KEYSTONE XL PIPELINE PROJECT

KEYSTONE XL PIPELINE PROJECT PIPELINE ROUTE VARIATION FORM			
1	<b>VARIATION TYPE:</b> Refinement: <input type="text"/> Reroute: <input checked="" type="checkbox"/> Footprint: <input type="text"/> Design: <input type="text"/> Centerline: <input checked="" type="checkbox"/> Pump Station: <input type="text"/> Valve Site: <input type="text"/> CAR: <input type="text"/>		
2	<b>LOCATION:</b> Sketch: <input type="text" value="Attached"/> Pictures: <input type="text" value="N/A"/> State: <input type="text" value="SD"/> County: <input type="text" value="Haakon"/> Quad Map: <input type="text" value="N/A"/> Township: <input type="text" value="003N"/> Range: <input type="text" value="022E"/> Aerial Map: <input type="text" value="See attached map sheet"/> Section: <input type="text" value="021, 028, 027"/> Centerline: <input type="text" value="6/11/2013"/> MP: <input type="text" value="465.41"/> to <input type="text" value="465.78"/>

**KEYSTONE XL PROJECT**  
**RV-0497-01 ROUTE VARIATION**

DWG: XL-46-P-9299-RV-497-01 SHEET: 1

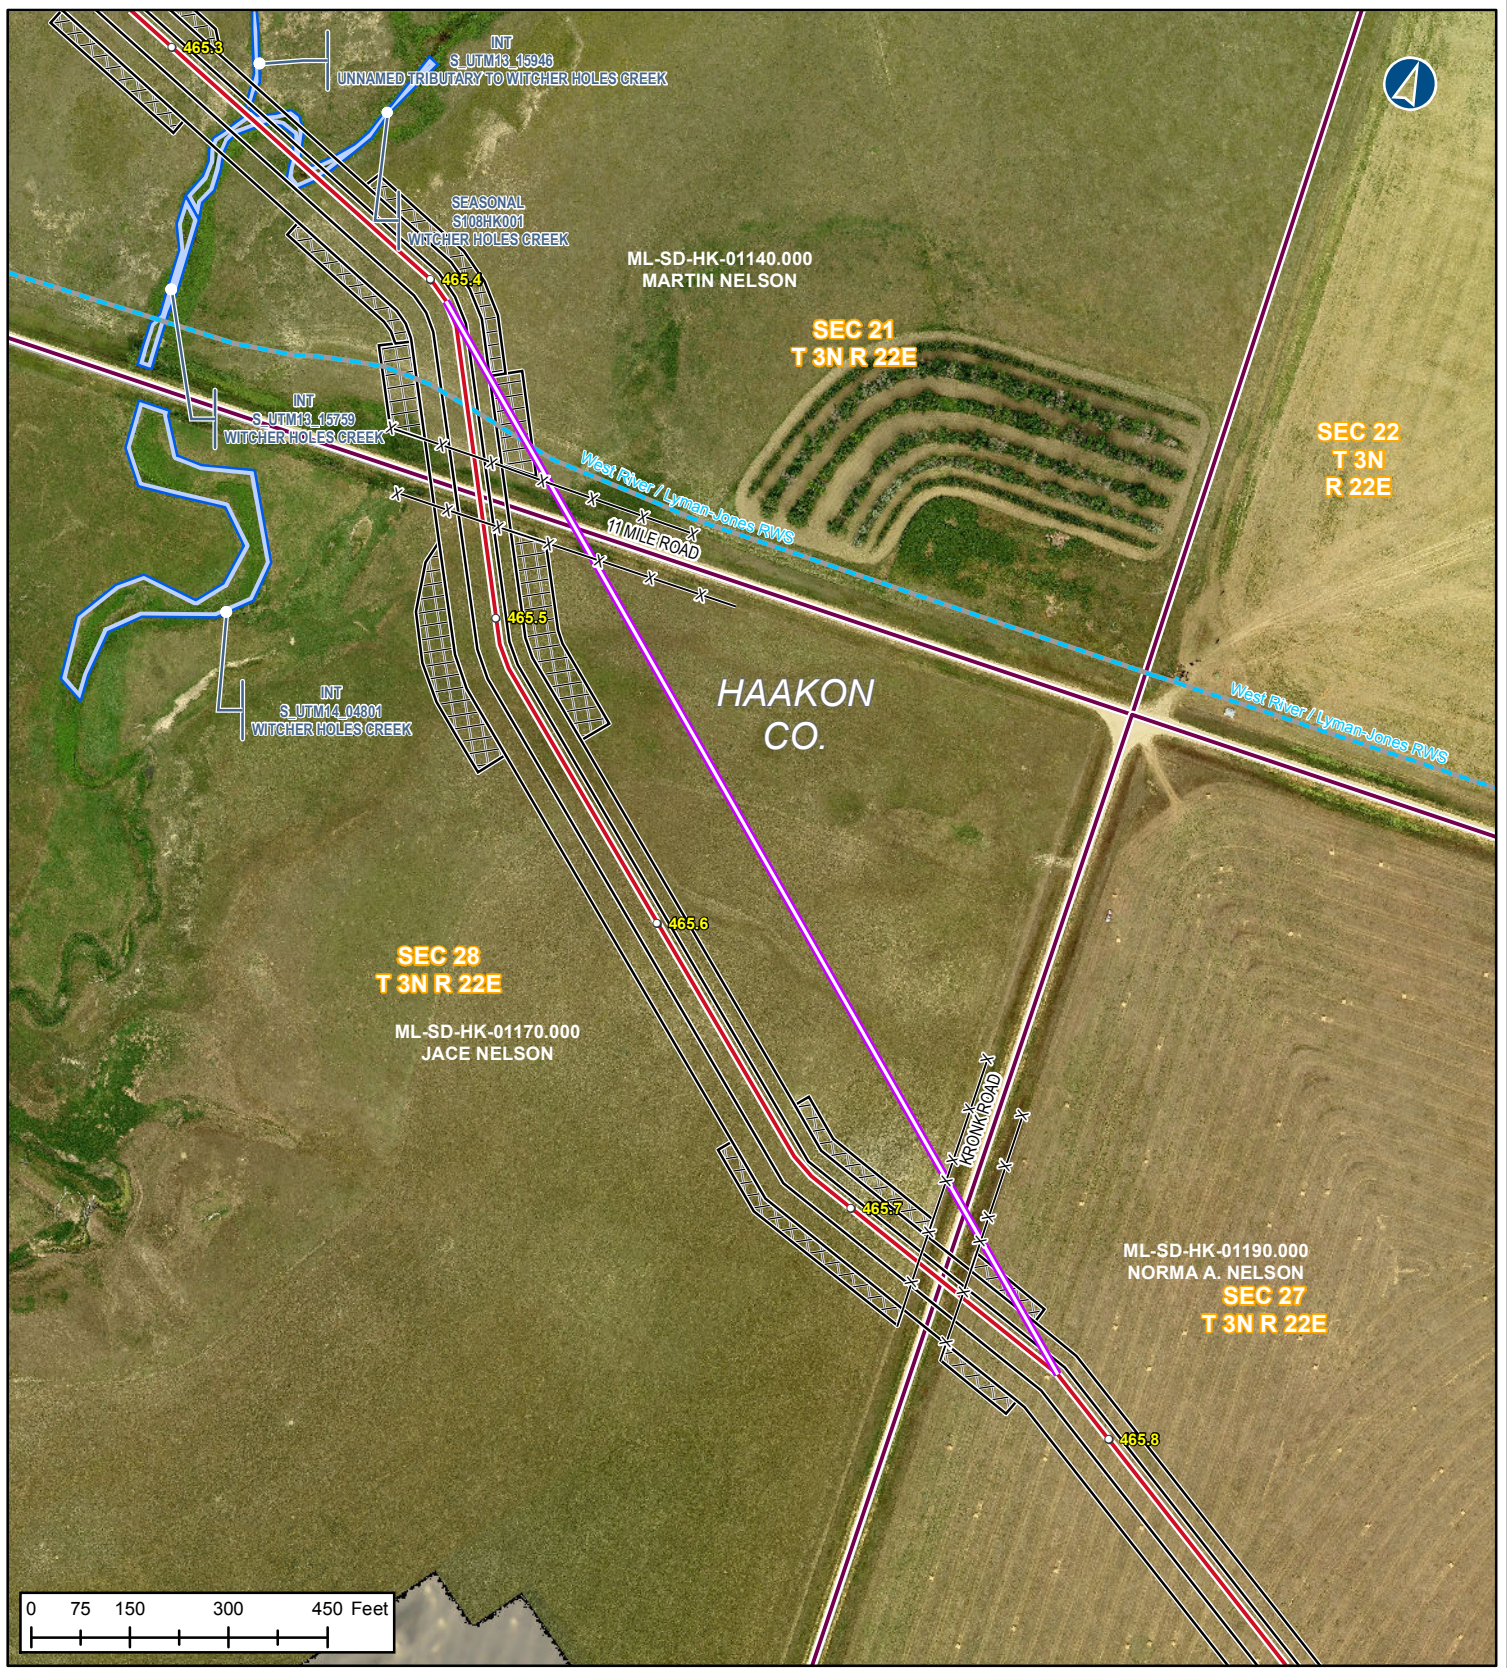
3	<b>REASON FOR ROUTE VARIATION</b> (Please include reason for route variation): <div style="border: 1px solid black; padding: 5px; margin-top: 5px;"> <p>The primary reason for this proposed reroute is to shift the CL to avoid cutting a hill way down to avoid a deep bore pit. This CL reroute was originally approved with conditions through PTR #130 (attached).</p> <p>This reroute has been proposed by Engineering based on recommendations from construction team (MPS) and field recon (civil survey).</p> </div>		
	<b>DETAIL ROUTE VARIATION</b> (Please describe route variation in detail): <div style="border: 1px solid black; padding: 5px; margin-top: 5px;"> <p>This reroute begins near MP 465.41 and deviates ~8.5° east of the current CL. It continues straight southeast for ~1,875 ft., rejoining the current CL near MP 465.8. This reroute essentially straightens the CL between the mentioned MPs.</p> <p>Tracts Impacted:                      ML-SD-HK-01140.000 (Martin Nelson)                      ML-SD-HK-01170.000 (Jace Nelson)                      ML-SD-HK-01190.000 (Norma A. Nelson)</p> </div>

Is this RV absolutely necessary?

FYI  
Met with L/O ( Nelson ) today to discuss RV's on his land. We staked out line of site, reviewed with L/O and made our case. L/O has rejected 0496-01 in favor of original line due to erosion concerns but has accepted 0497-01 as proposed.  
Thanks  
Craig  
Universal Ensco, Inc., Pegasus International, Inc., UP International Inc. are UniversalPegasus International Companies

KEYSTONE XL PIPELINE PROJECT ROUTE VARIATION AUTHORIZATION FORM		
Date: 8/15/2013	Tracking Number: 0497-SD-P4-465.4-465.8-S	
Description: The primary reason for this proposed reroute is to shift the CL to avoid cutting a hill way down to avoid a deep bore pit. This CL reroute was originally approved with conditions through PTR #130 (attached).	MP: 465.4 to 465.8	Originated By: Engineering
	Variation Form Attached: Yes <input checked="" type="checkbox"/> No <input type="checkbox"/>	
TransCanada - Land Tina Hill	Variation: Approved <input checked="" type="checkbox"/> Rejected <input type="checkbox"/>	Date: 8-21-13
Comments:	If Rejected Why? Pending Loadings Approval	
TransCanada - Engineering Meera Kolhari	Variation: Approved <input checked="" type="checkbox"/> Rejected <input type="checkbox"/>	Date: 8/19/13
Comments:	If Rejected Why?	
Exp - Engineering Kevin McGlynn	Variation: Approved <input checked="" type="checkbox"/> Rejected <input type="checkbox"/>	Date: 8-21-13
